Detailed Site Plan Fallen Oak Townhomes

DSP-19066

SUBJECT: Detailed Site Plan DSP-19066
Type 2 Tree Conservation Plan TCP2-034-96-08
Fallen Oak Townhomes

1 - 1 - WSSC Plan Review Comments

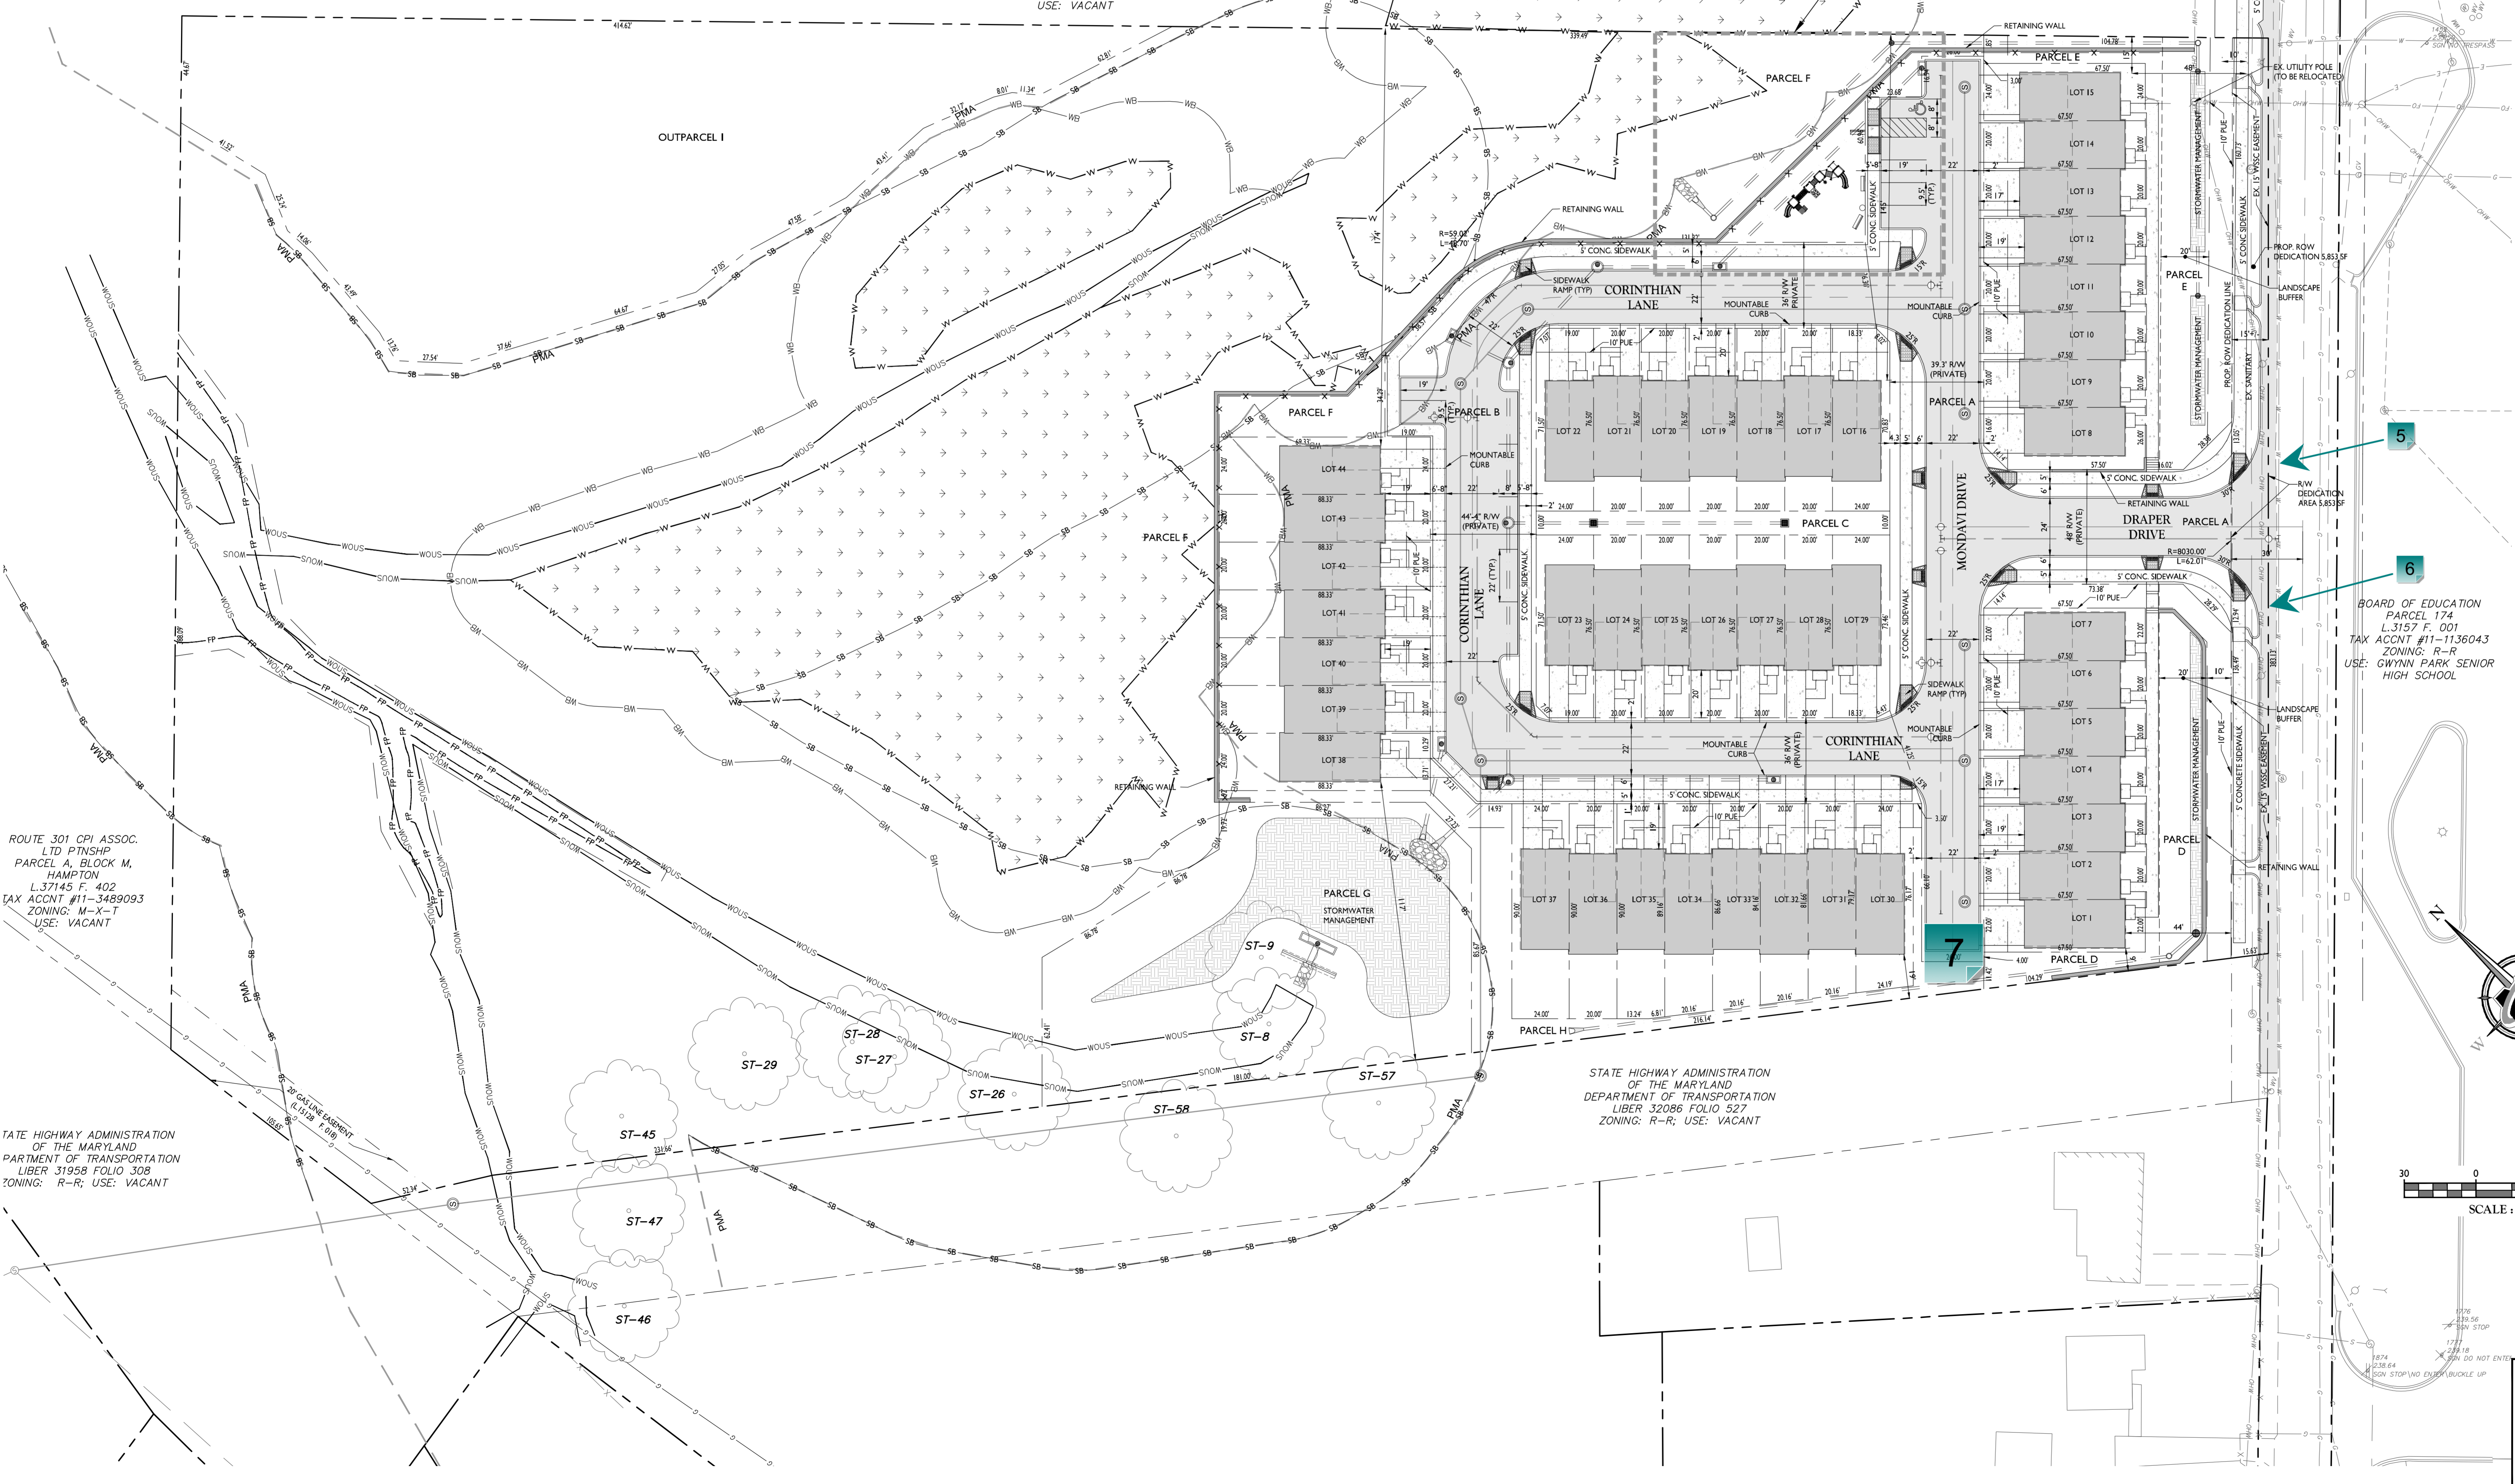
6. Acquisition of off-site easements from other property owners will be required for the proposed (water/sewer) extension(s). The Applicant is responsible for obtaining the easements. Delineate and show the proposed off-site easement limits on plan. See WSSC Design Manual C-2.1

16-in cast iron pipe 1965-3142

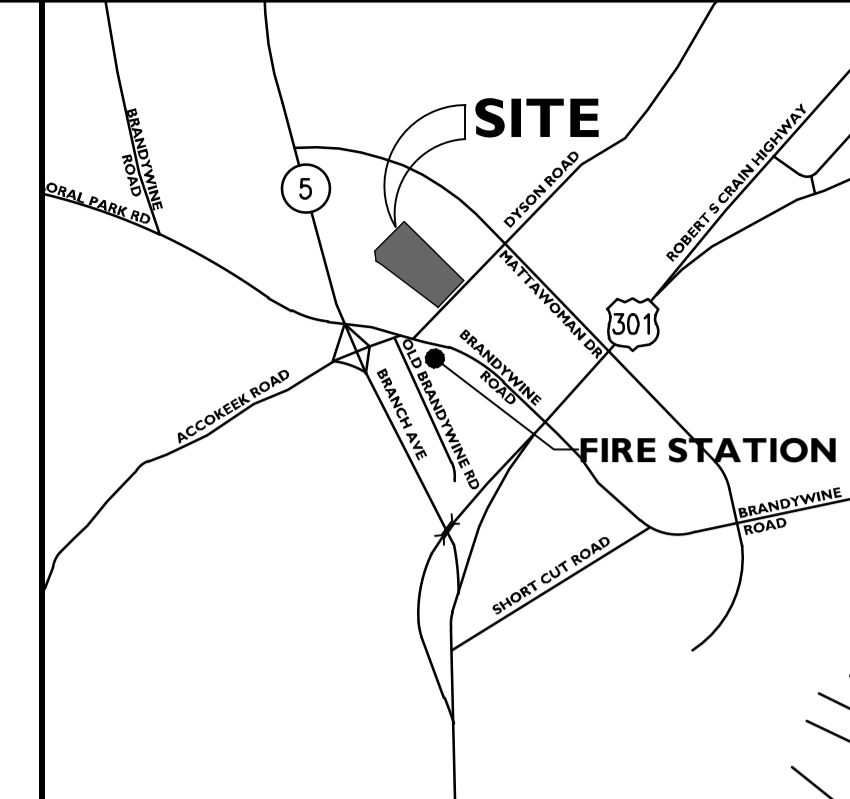
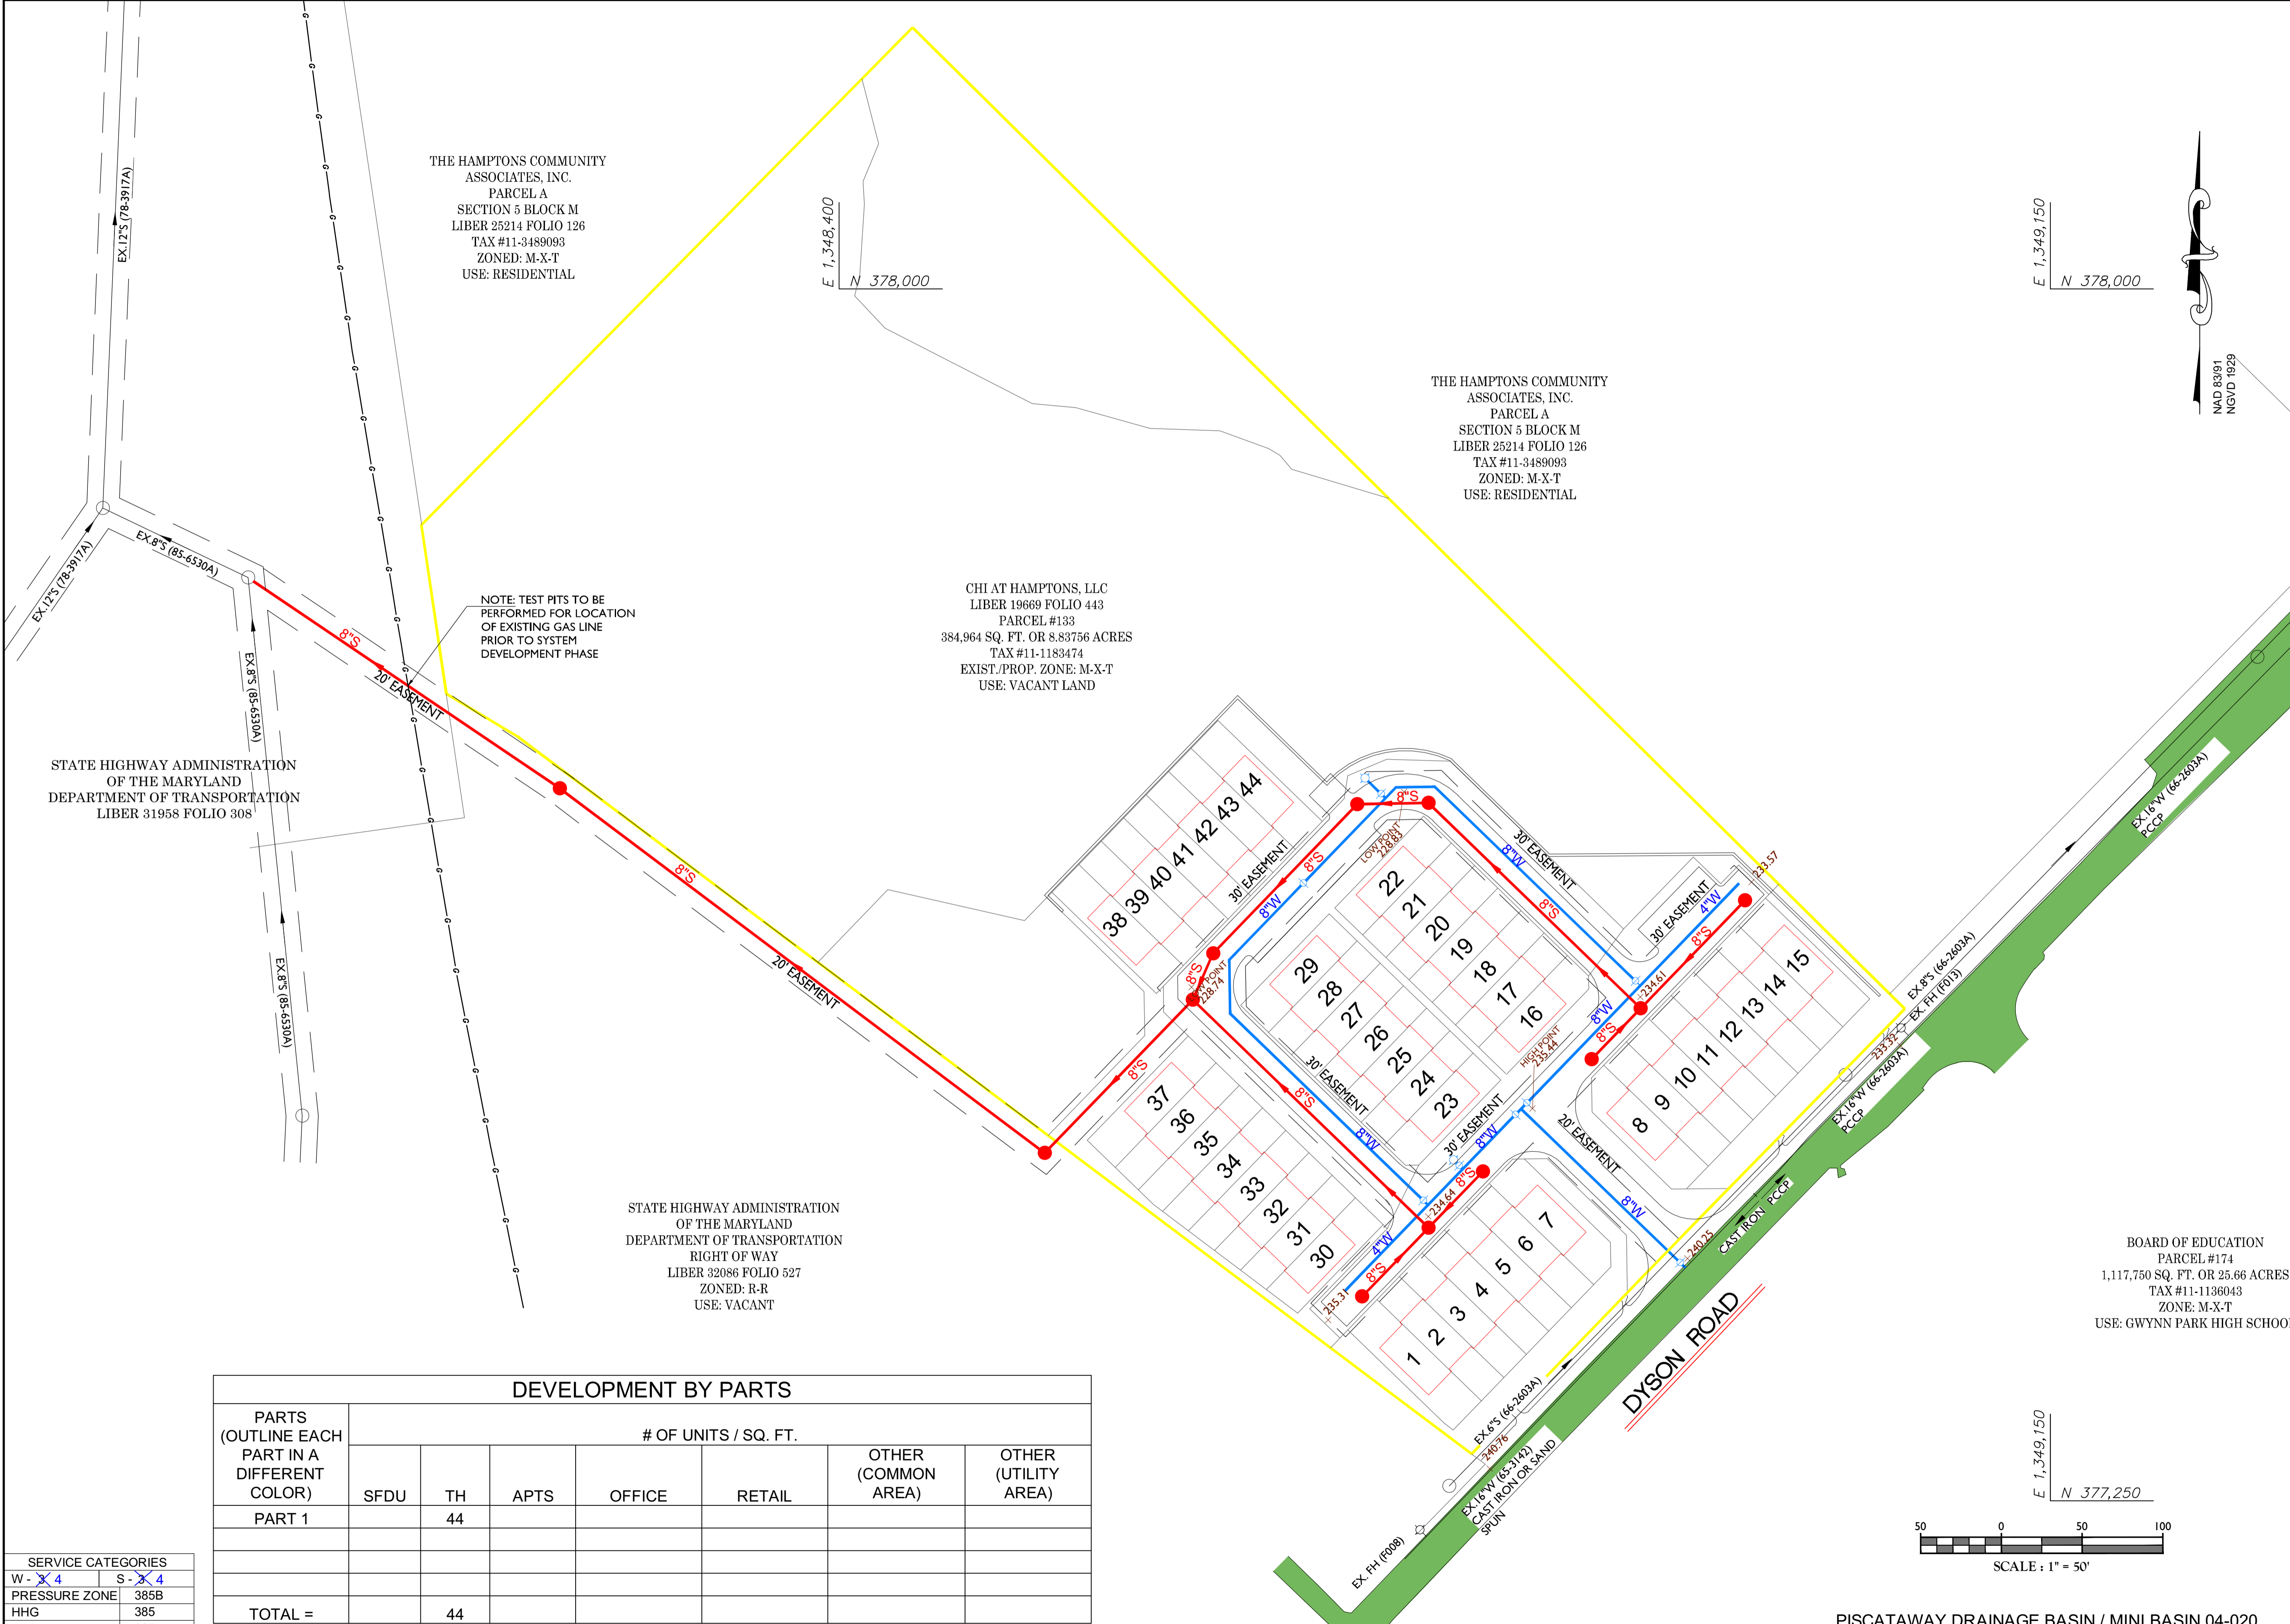
7 - Blow offs
